# UNITED STATES PATENT AND TRADEMARK OFFICE

APPLICATION NO.	FILING DATE	FIRST NAMED INVENTOR	ATTORNEY DOCKET NO.	CONFIRMATION NO.
09/955,351	09/17/2001	Nathan T. Lee	11576.56US01	2171

**Office Action Summary**

FIG.2C

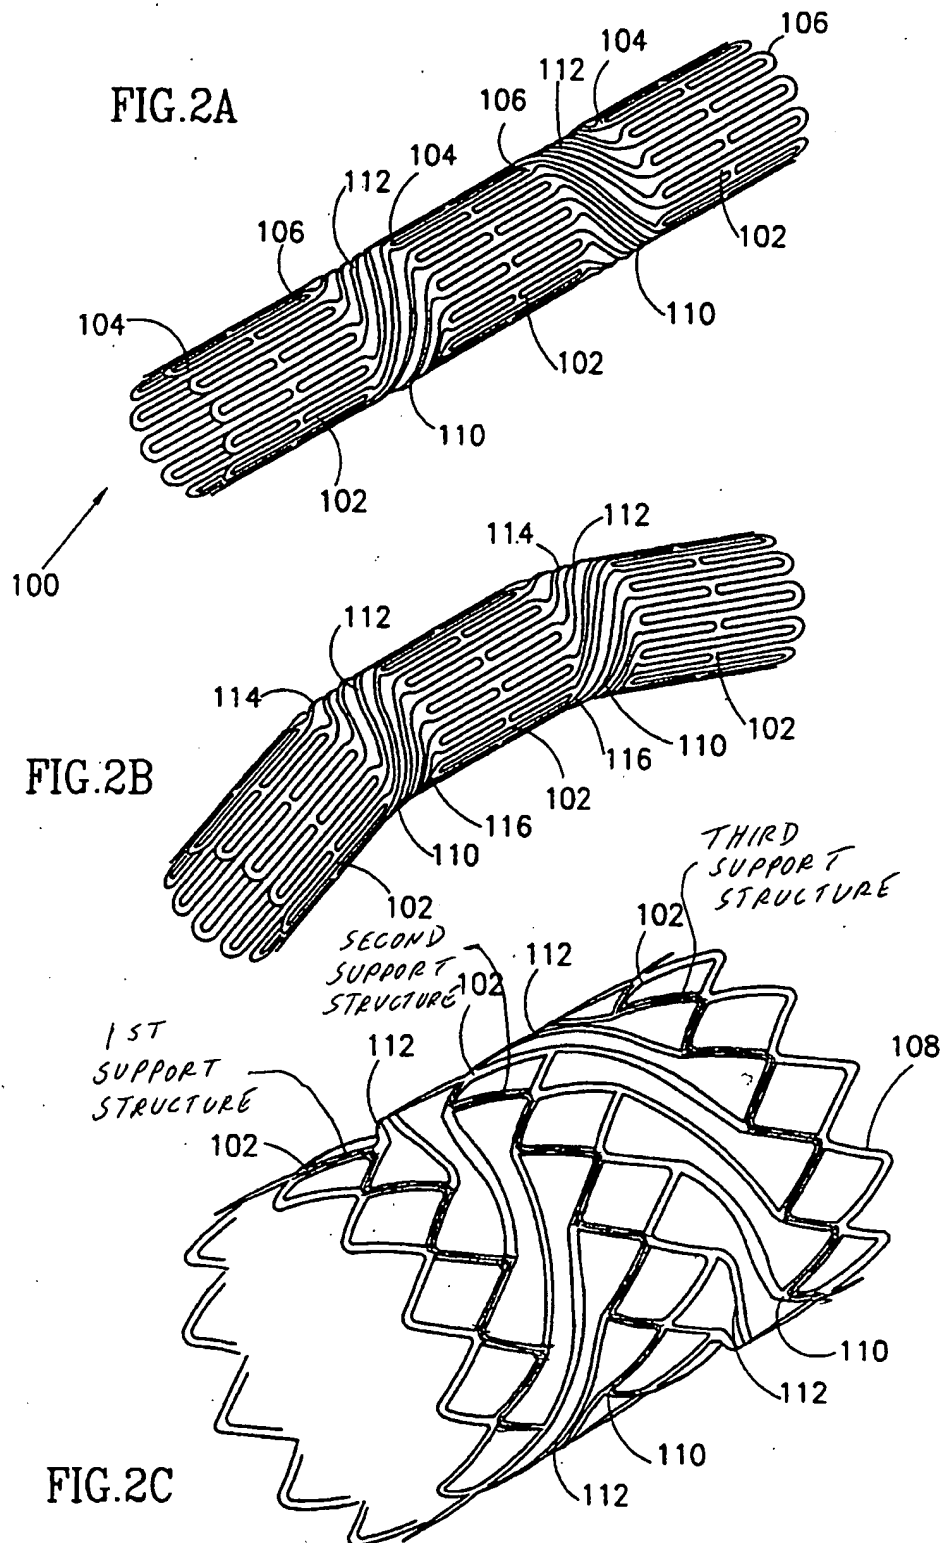
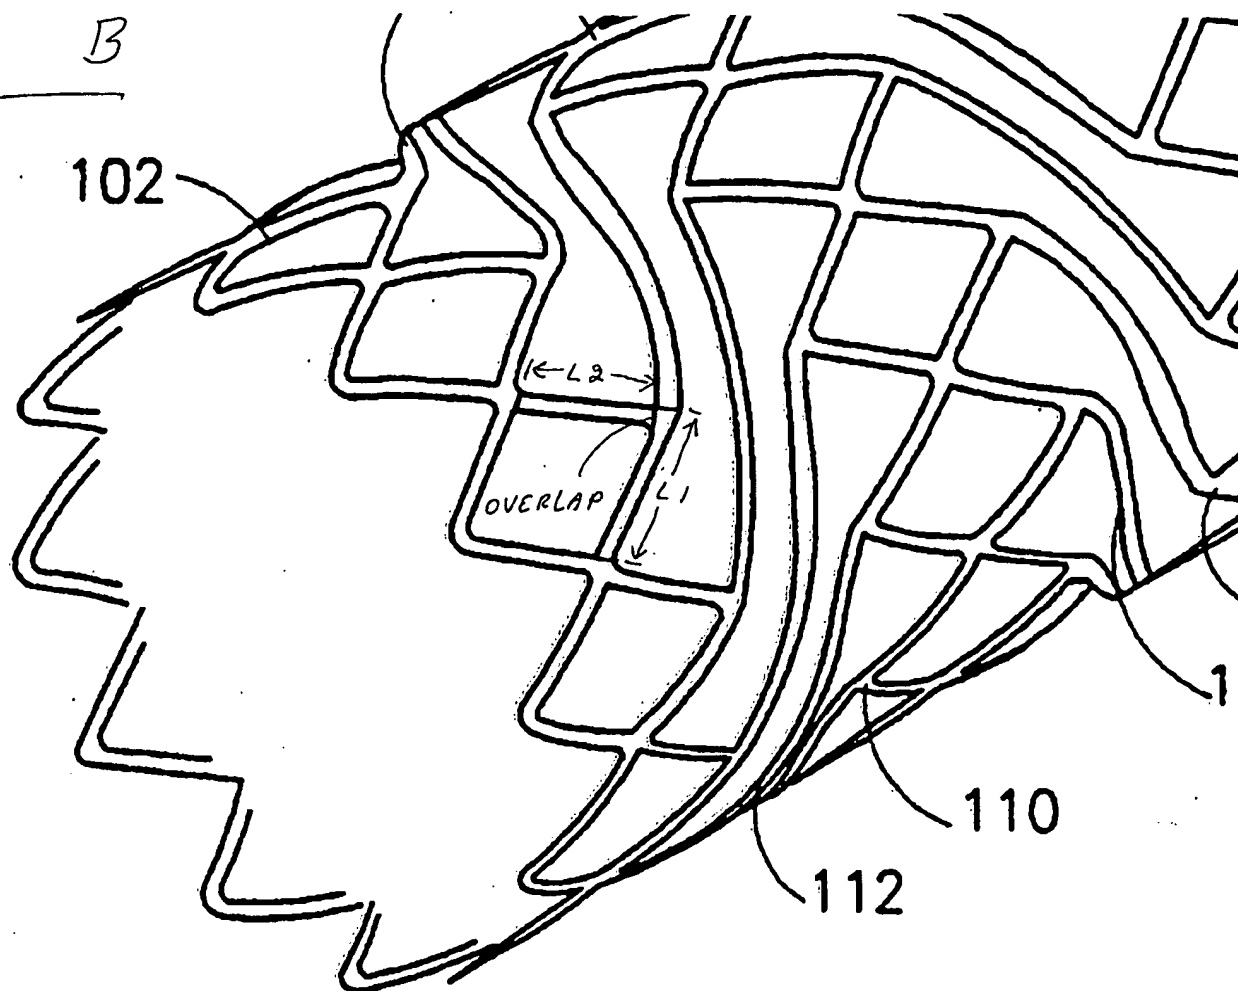
Claims 1, 9, 10 and 12 are rejected under 35 U.S.C. 102(b) as being anticipated by Pinchasik et al. (5,449,373). Pinchasik et al. disclose a stent body having a plurality of adjacent circumferential support structures (one of which is labeled first support structure in appendix A, another being the one directly to the left of [and being a mirror image of] the first support structure, another being the one labeled second support structure, another being the one directly to the right of [and being a mirror image of] the second support structure, another being the one labeled third support structure, another being the one directly to the right of [and being a mirror image of] the third support structure) including longitudinal struts

interconnected at apex portions, wherein each support structure is directly connected to an adjacent support structure (i.e. the adjacent support structure which is a mirror image of it) at a plurality but not all apex portions (For example, the support structure which is labeled first support structure in appendix A is directly connected to an adjacent support structure [at its left] at the apex portions on the left side of the first support structure, but not the apex portions on the right side of the first support structure.), and wherein some of the support structures (e.g. the first support structure) are interconnected to an adjacent support structure (e.g. the second support structure) by circumferential connecting struts (e.g. 112) extending between a plurality, but not all of the apex portions of the interconnected pairs of circumferential support structures (For example, the circumferential connecting struts 112 extending between the first and second support structures do not extend to the apex portions on the left side of the first support structure.) wherein said interconnected apex portions are circumferentially offset relative to one another (as seen in figures 2A, 2B and 2C). As to claim 9, the circumferential connecting struts on the left side of figure 2C of Pinchasik et al. extend in a first direction and the circumferential connecting struts on the right side of figure 2C extend in a

second direction opposite the first direction. As to claim 10, some of the longitudinal struts (having length L1) are longer than other longitudinal struts (having length L2) and provide a longitudinal overlap as shown in the attached appendix B.
